**INVER GROVE HEIGHTS
PLANNING COMMISSION AGENDA**

**TUESDAY, SEPTEMBER 17, 2013 – 7:00 p.m.
City Council Chambers - 8150 Barbara Avenue**

**PLANNING REPORT
CITY OF INVER GROVE HEIGHTS**

REQUEST: Preliminary and Final Plat, Preliminary and Final PUD Development Plan Amendment and Vacation of certain Drainage and Utility Easements for Argenta Hills 8th Addition

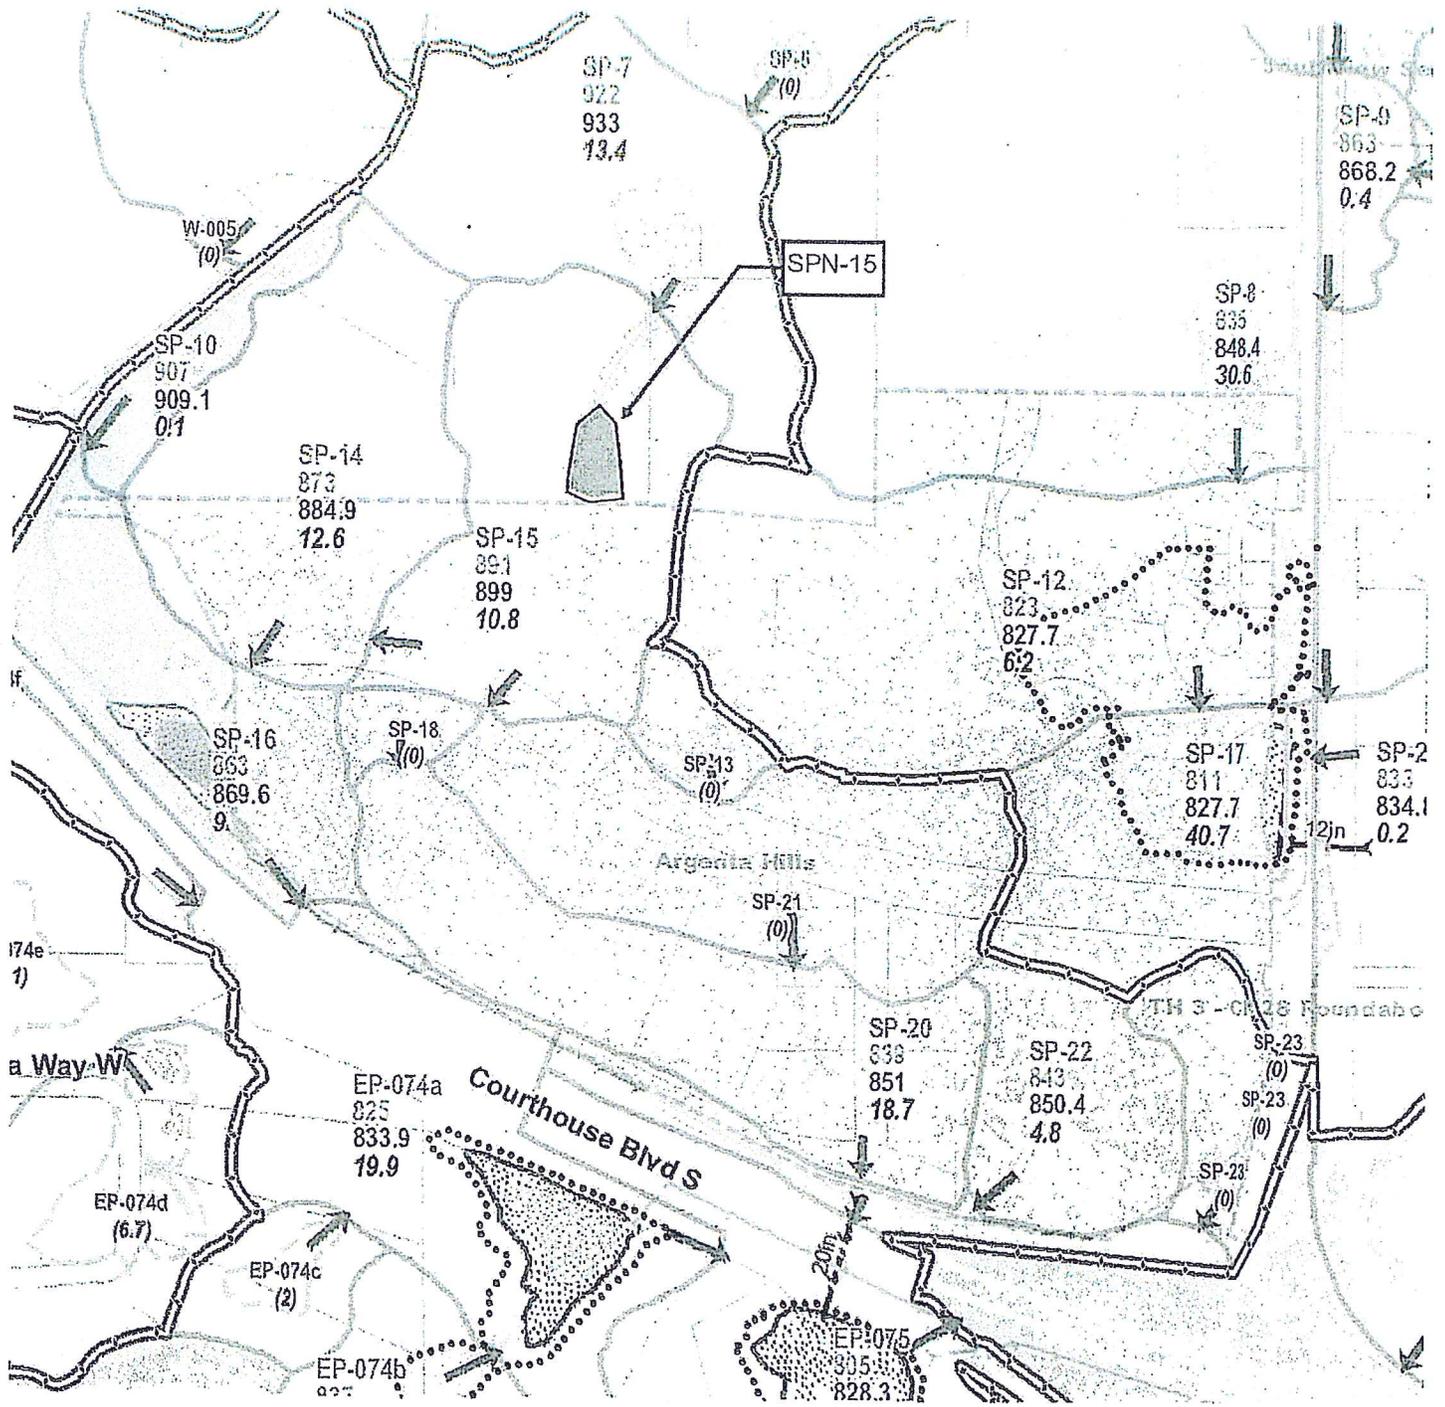
C4. The Developer shall provide a street maintenance agreement for the private road that addresses access, construction, maintenance and all costs associated with the private road. The homeowner's association will be responsible for all future maintenance needs and associated costs.

C5. Trunk sanitary sewer and watermain up-sizing costs are being reviewed. They will be included in the developer's agreement as a City responsibility. Twelve-inch watermains and 12-inch sanitary sewers are considered trunks and the City has credited these types of improvements in the past because they benefit other properties to be developed in the future. Developer is responsible for standard lateral (8-inch to 10-inch) water and sanitary sewer main expenses and the associated Northwest Area charges.

C7. City will identify valley gutter locations required at hammerhead turn-a-round and intersections as necessary.

C8. The City Engineer reserves the right to provide additional comments upon further review on this and subsequent submittals.
